SERVICE BULLETIN

This is to notify you of a problem concerning the 'I/O BD JVS to JAMMA' on the following Game kits; World Series 99', Zombie Revenge, VS 2000

Location of paths that need to be severed

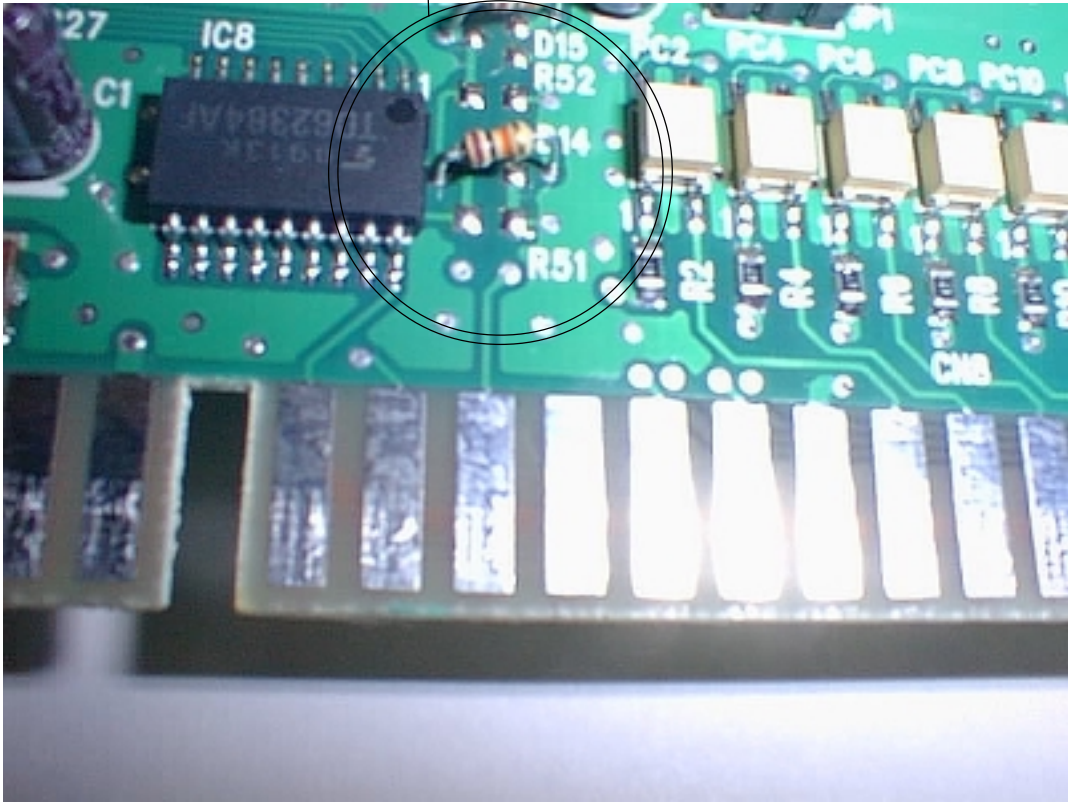
PROBLEM: Sometimes the game will not credit though the coinmeter works normally. Alternately coin meter sometimes counts up during power up.

NOTE: These problems only occurred with BD# 838-13683-92 only, and PCB marked "SDC-1" only (There are two vendors for this PCB). If your Board says "AUTO-10" please disregard this bulletin.

SOLUTION: Make sure the PCB is marked "SDC-1" (Not "AUTO-10"). Cut PCB Pattern. (Near the IC8, 2 pos. shown below in detail)

Image of area in question with indication of suggested location of cuts to paths
